LANDING GEAR - LANDING GEAR WARNING HORN REPLACEMENT

425

441

CQB-32-01
Page 1 of 19

Figure 1. Before Modification (Sheet 1)

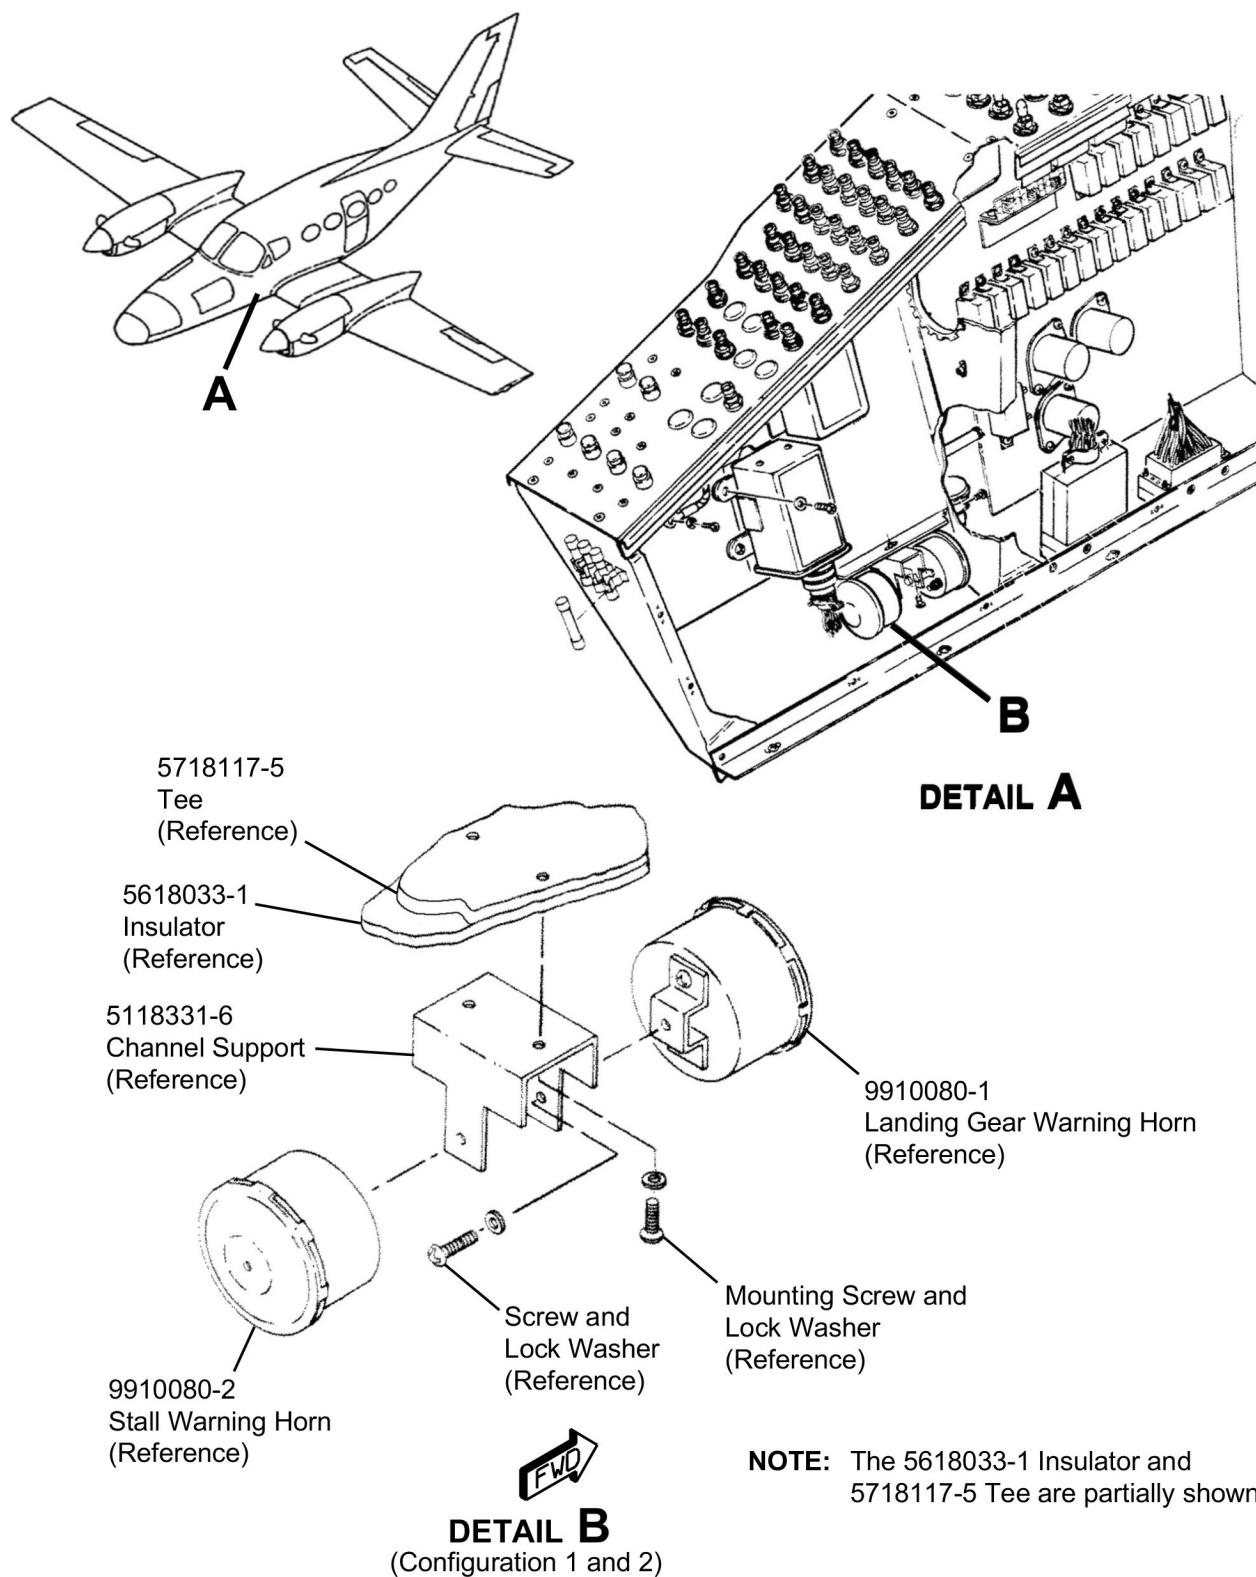
2. (Refer to Figure 1, Sheet 1.) Remove the 9910080-1 Landing Gear Warning Horn as follows:
 - A. Disconnect and label the electrical wiring from the 9910080-1 Landing Gear Warning Horn and the 9910080-2 Stall Warning Horn.
 - B. Remove the four rivets from the 5718117-5 Tee. (Refer to the applicable Maintenance Manual, Chapter 51, Fastener Installation and Removal.)
 - C. Remove and discard the screw, nut, and lock washer from the 9910080-1 Landing Gear Warning Horn.
 - D. Remove and discard the screw, nut, and lock washer from the 9910080-2 Stall Warning Horn.
 - E. Remove and keep the two mounting screws from the 5118331-6 Channel Support.

6. (Refer to Figure 1, Sheet 1.) Remove the 9910080-1 Landing Gear Warning Horn as follows:

- A. Disconnect and label the electrical wiring from the 9910080-1 Landing Gear Warning Horn and the 9910080-2 Stall Warning Horn.

- B. Remove the four rivets from the 5718117-5 Tee. (Refer to the applicable Maintenance Manual, Chapter 51, Fastener Installation and Removal.)

- C. Remove and discard the screw and lock washer from the 9910080-1 Landing Gear Warning Horn.

- D. Discard the 9910080-1 Landing Gear Warning Horn.

- E. Remove and keep the screw and lock washer from the 9910080-2 Stall Warning Horn.

- G. Remove and keep the mounting screws, lock washers, and the 5118331-6 Channel Support.

Figure 2. After Modification (Sheet 1)

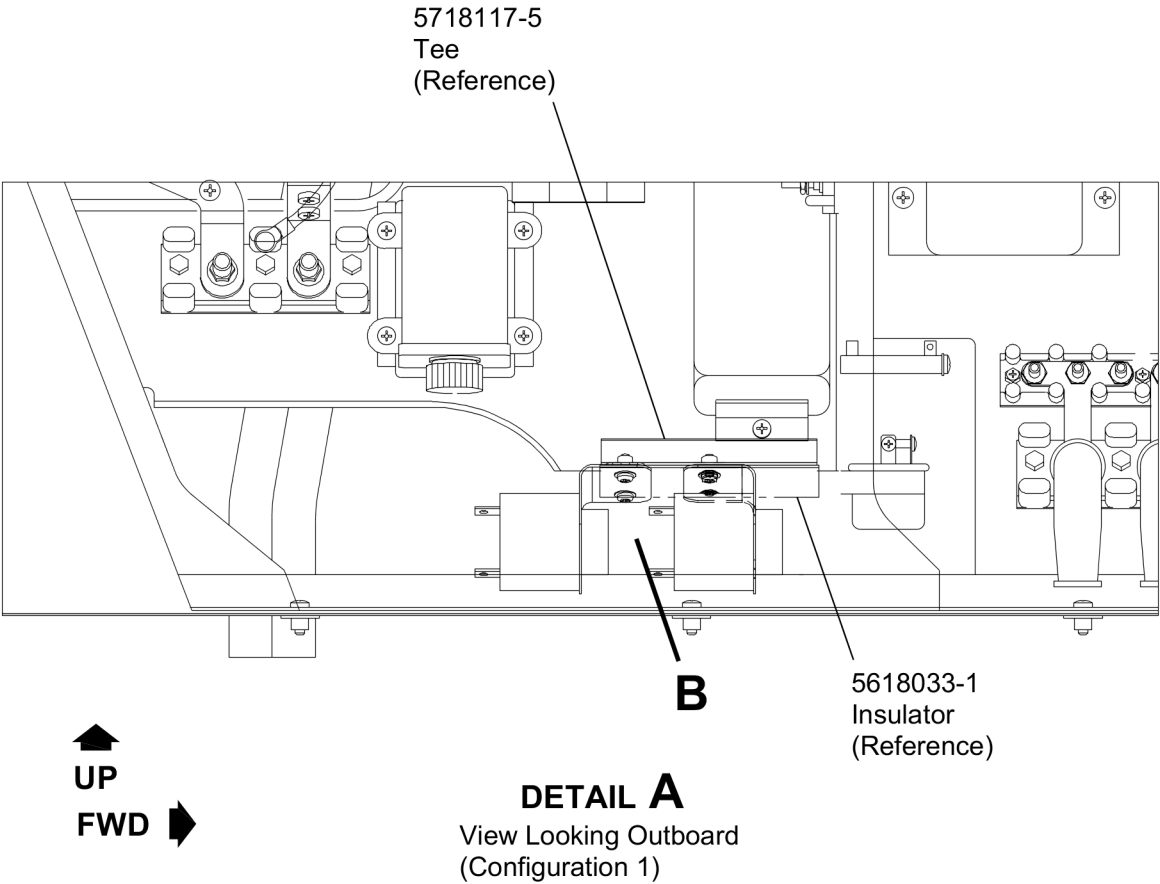
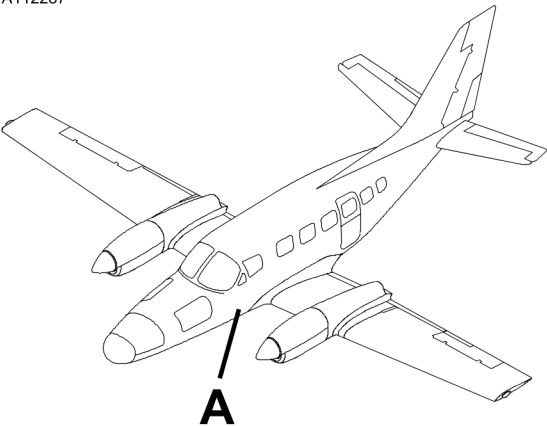
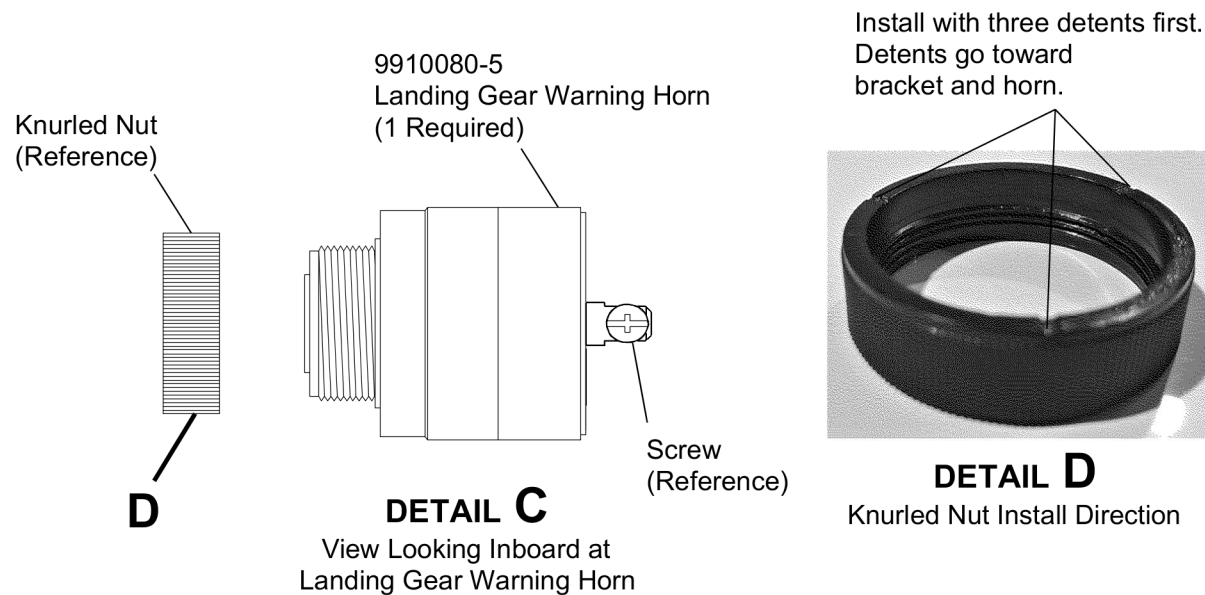
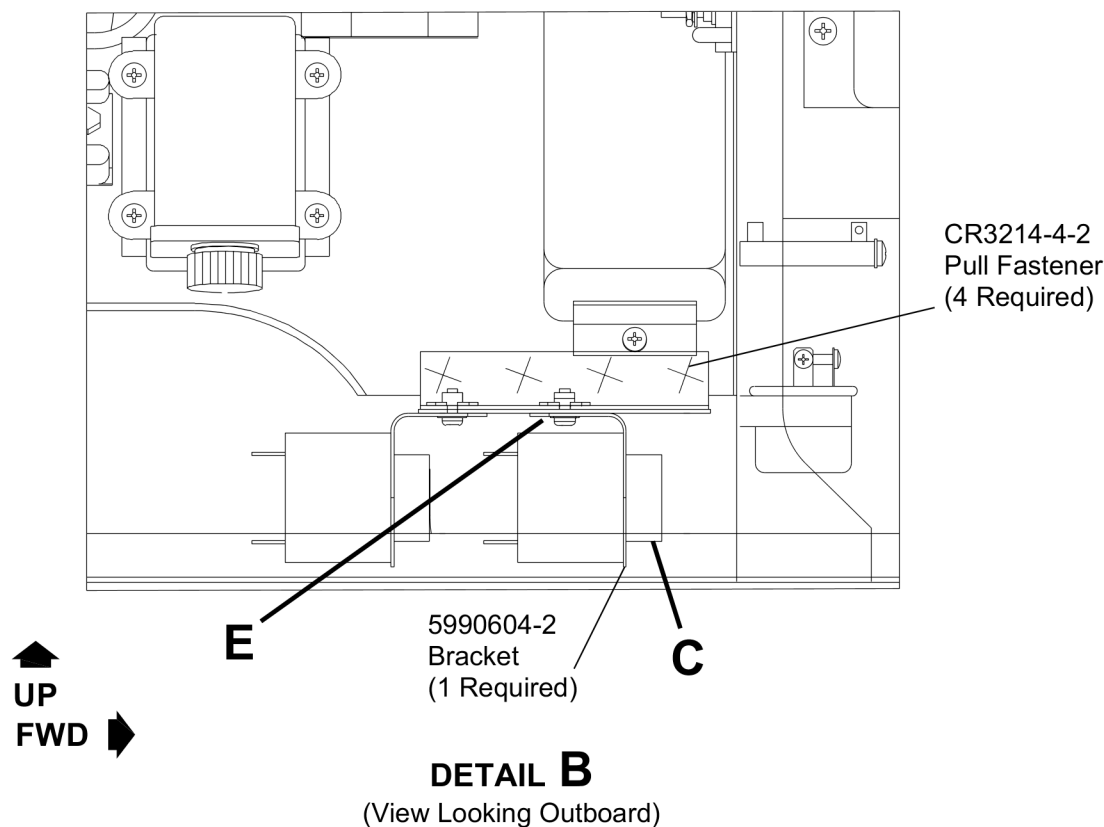
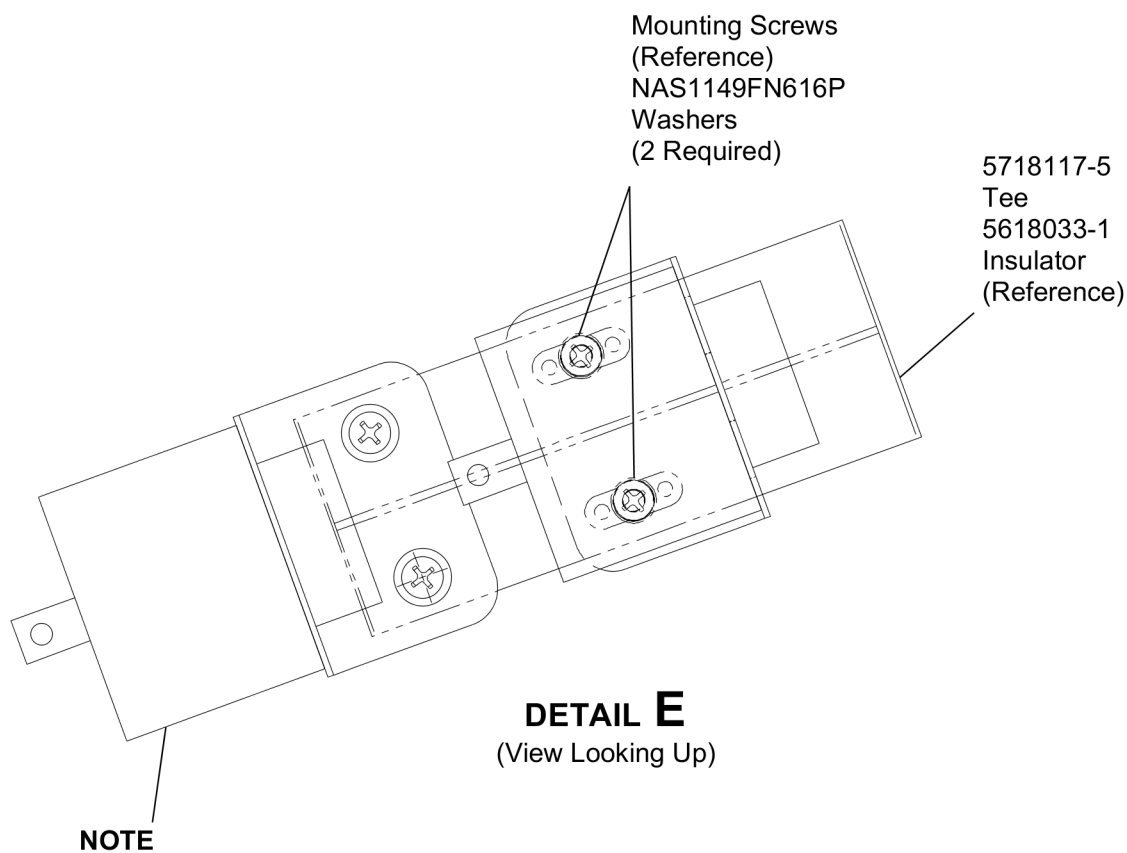
NOTE: The kept 5618033-1 Insulator will be used for installation.
3. (Refer to Figure 2, Sheet 1, 2, and 3.) Install the 9910080-5 Landing Gear Warning Horn as follows:
 - A. Install the 9910080-6 Stall Warning Horn. (Refer to the CQB-34-01: Stall Warning Horn Replacement, **CONFIGURATION 1**.)
 - B. Align the existing holes of the 5618033-1 Insulator onto the 5718117-5 Tee.
 - C. Put the 5990604-2 Bracket onto the existing holes of the 5618033-1 Insulator.
 - D. Install the two mounting screws and two NAS1149FN616P Washers into the 5990604-2 Bracket.
 - E. Install the 9910080-5 Landing Gear Warning Horn into the 5990604-2 Bracket.
 - F. Install the knurled nut onto the 9910080-5 Landing Gear Warning Horn.

NOTE: The plastic knurled nut must be installed with the three indents toward the bracket and horn assembly. On the internal circumference, the smooth side without threads is installed first, towards the bracket and horn. This technique of installation will make sure the nut fully seats against the bracket and not bottom-out on the threads. If not installed correctly the knurled nut will bottom-out on the threads and the horn assembly will not be fully tightened to the bracket.
 - G. Install the 5718117-5 Tee with four CR3214-4-2 Pull Fasteners onto the frame.
 - H. Install the labeled electrical wiring and screws into the 9910080-5 Landing Gear Warning Horn.

Figure 3. After Modification (Sheet 1)

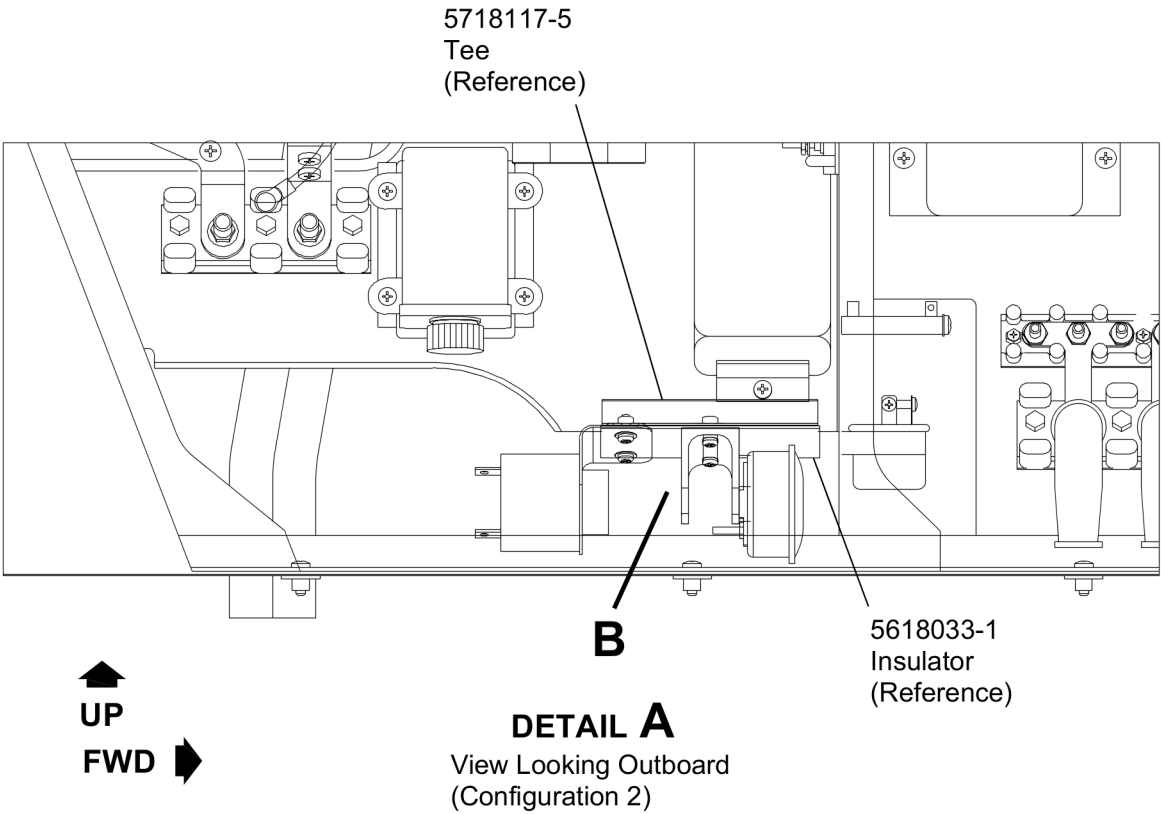
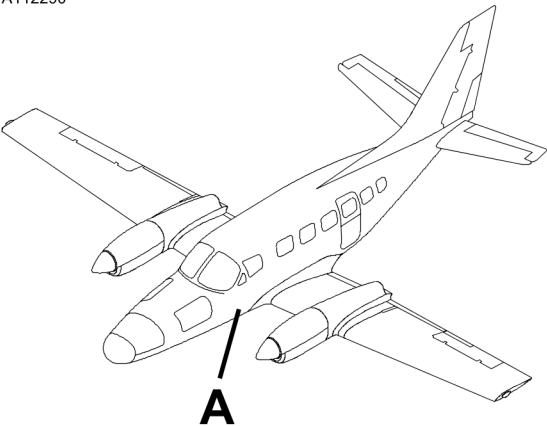
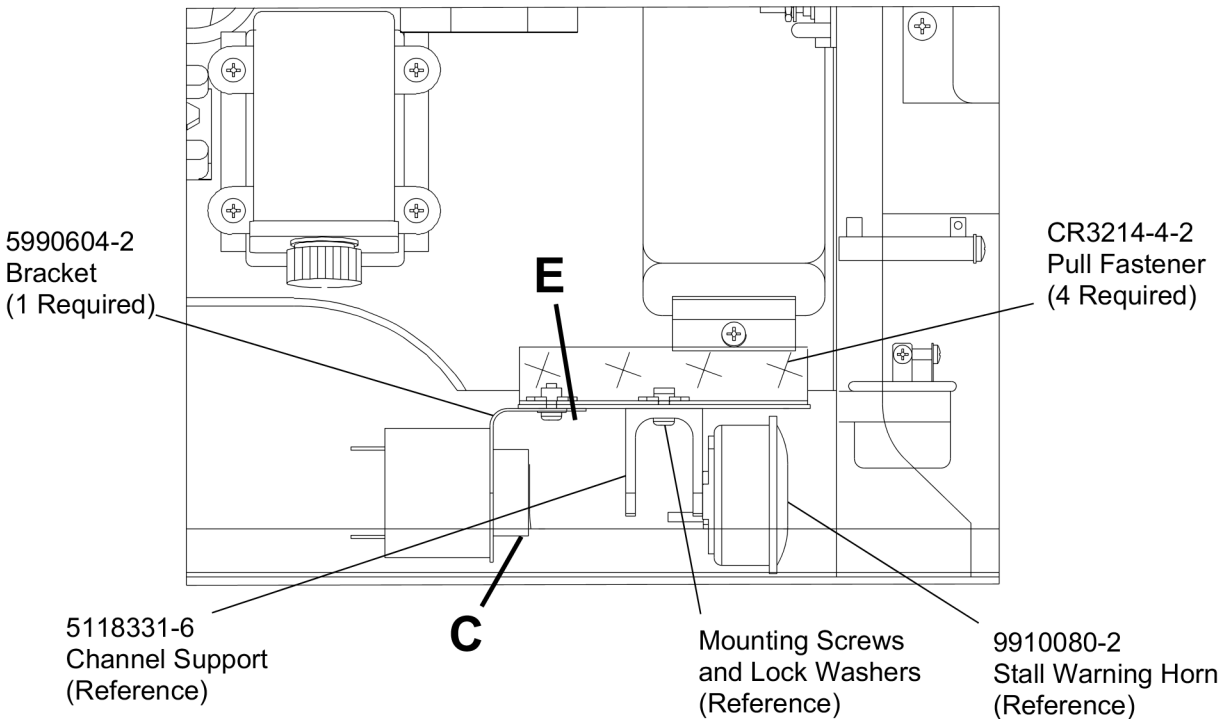
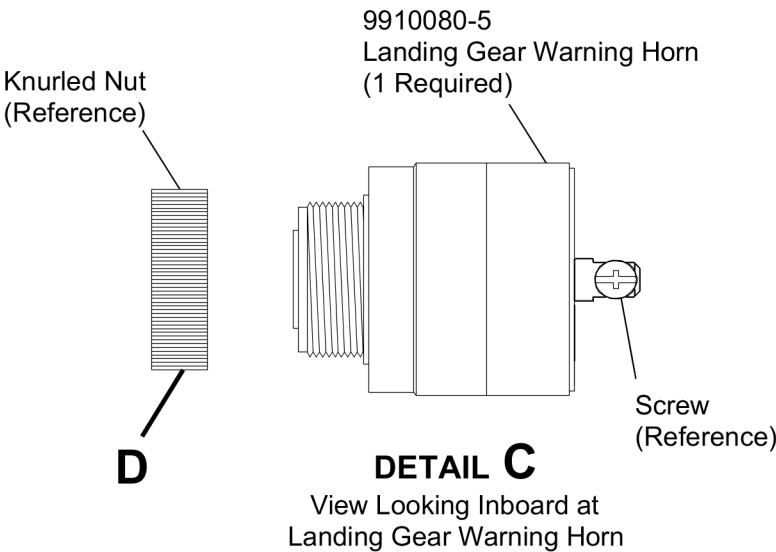
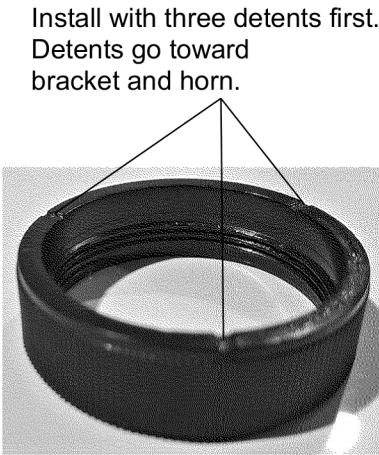
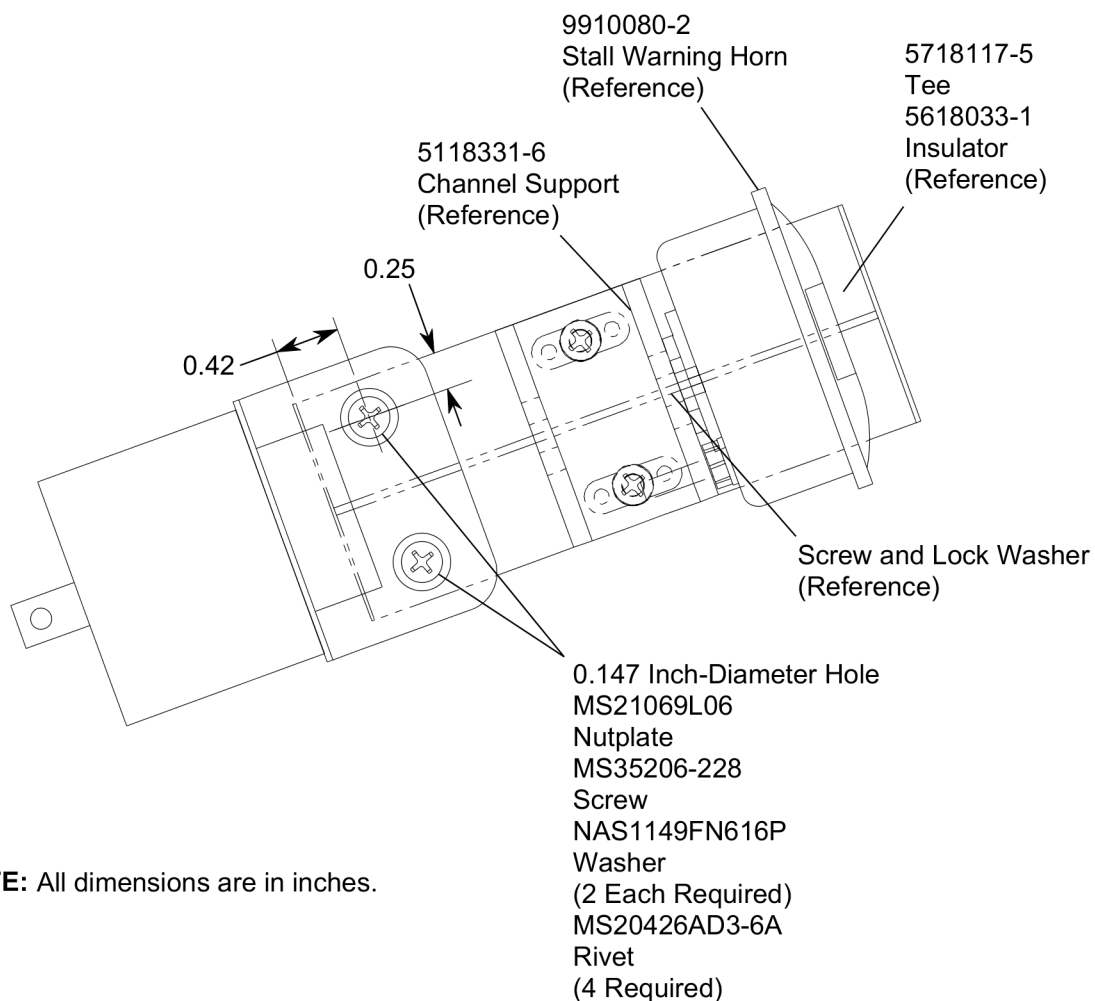
7. (Refer to Figure 3, Sheet 1, 2, and 3.) Install the 9910080-5 Landing Gear Warning Horn as follows:

- A. Align the existing holes of the 5618033-1 Insulator onto the 5718117-5 Tee.

- B. Put the 5990604-2 Bracket onto the 5618033-1 Insulator.

- C. Match drill the two 0.147 inch diameter holes of the 5990604-2 Bracket into the 5618033-1 Insulator and the 5718117-5 Tee.

- D. Install two MS21069L06 Nutplates with four MS20426AD3-6A Rivets onto the 5718117-5 Tee. (Refer to the applicable Maintenance Manual, Chapter 51, Fastener Installation and Removal.)

- E. Put the drilled holes of the 5618033-1 Insulator onto the drilled holes of the 5718117-5 Tee.

- F. Install the 5990604-2 Bracket with two MS35206-228 Screws and two NAS1149FN616P Washers.
- G. Install the 9910080-5 Landing Gear Warning Horn into the 5990604-2 Bracket.
- H. Install the knurled nut onto the 9910080-5 Landing Gear Warning Horn.

NOTE: The plastic knurled nut must be installed with the three indents toward the bracket and horn assembly. On the internal circumference, the smooth side without threads is installed first, towards the bracket and horn. This technique of installation will make sure the nut fully seats against the bracket and not bottom-out on the threads. If not installed correctly the knurled nut will bottom-out on the threads and the horn assembly will not be fully tightened to the bracket.

- I. Install the 5118331-6 Channel Support with the mounting screws and lock washers in the existing holes of the 5618033-1 Insulator.
- J. Install the 9910080-2 Stall Warning Horn onto the forward side of the 5118331-6 Channel Support with the screw and lock washer.
- K. Install the 5718117-5 Tee with four CR3214-4-2 Pull Fasteners onto the frame.
- L. Install the labeled electrical wiring into the 9910080-2 Stall Warning Horn.
- M. Install the labeled electrical wiring and screws into the 9910080-5 Landing Gear Warning Horn.
